Southern Nuclear Operating Company
Vogtle Electric Generating Plant Units 3 and 4
Supplement to Request for License Amendment:
Update of Common Qualified (Common Q) Platform
Software Program Manual and Topical Report (LAR-15-017S1)

Response to NRC Staff Request for Additional Information (RAI)

Regarding LAR-15-017 (LAR-15-017S1)

Exhibit 2-1
Westinghouse Organization Chart*

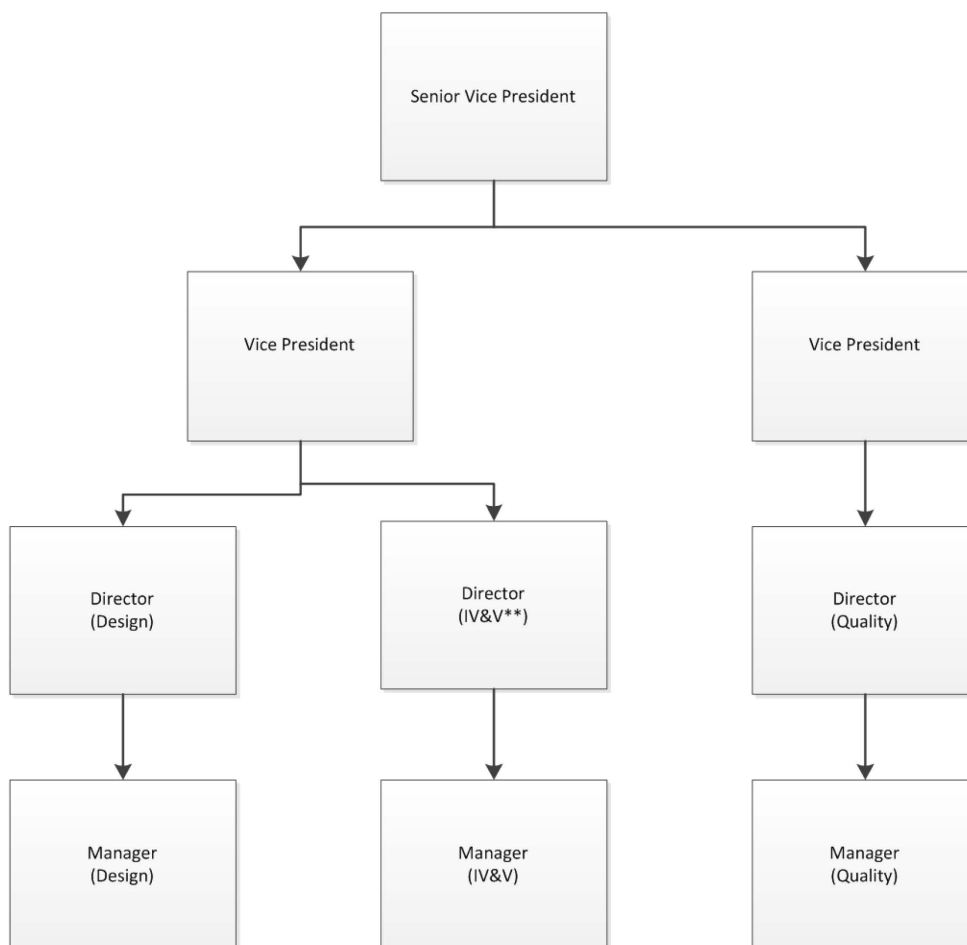
2. Common Q SPM Section 4.3.1, “Organization” / Exhibit 2-1 – Design/IV&V Team Organization (Page 3 of Enclosure 3)

The alternative proposes to update Exhibit 2-1 – Design/IV&V Team Organization to show that design team and the Independent Verification & Validation (IV&V) team are in separate organizations at least to the Director level. The justification of the alternative states:

The IV&V team and the design team are not under the same organization to maintain independence. This level of independence exceeds the criteria in the SPM.

The NRC staff requests the Licensee to describe how the proposed alternative to Exhibit 2-1 “exceeds the criteria in [Section 4.3.1 of] the SPM,” actually meets the site-specific requirements in the WCAP. Update the requested amendment accordingly.

After the NRC-approved Common Q SPM was issued, the Westinghouse Safety System development organization structure changed. Instead of updating the organization chart to reflect the new organization, the amendment request clarifies that the organization chart is provided as an example only and is meant to reflect the minimum level of independence required by the SPM. This is consistent with how Exhibit 2-1 is referred to in Section 2 of the SPM. The actual organization structure may change in the future, but with the proposed changes it cannot change in such a way that would violate the independence requirements of Exhibit 2-1. This new organization chart (Figure A3-1) shows the same level of separation for the Design Team and IV&V Team as the current Exhibit 2-1, namely they are independent at the Director level.

However, the new organization chart should have shown the Quality Team being independent of the Design and IV&V Teams at the Vice President level instead of the Director level (as currently depicted). Therefore, the new organization chart in Figure A3-1 will be updated to show Quality independence at the Vice President Level.

The Westinghouse Safety System Development organization meets or exceeds the requirements from Exhibit 2-1 of the SPM and the newly proposed organization chart in Figure A3-1:

- The IV&V Team Director reports to a different Vice President than the Design Team Director. This exceeds the SPM requirement.
- The Independent Test Team (i.e., performing IV&V function) Director and Design Team Director report to the same Vice President. This meets the SPM requirement.
- The Quality Team reports to a different Senior Vice President than the Design and IV&V Teams. This exceeds the SPM requirement.

The IV&V team and the design team are not under the same ~~organization director~~ to maintain independence. This level of independence ~~exceeds~~ meets the criteria in the SPM.

In addition, license amendment request Figure A3-1 (SPM Exhibit 2-1) is replaced by the corrected figure below.
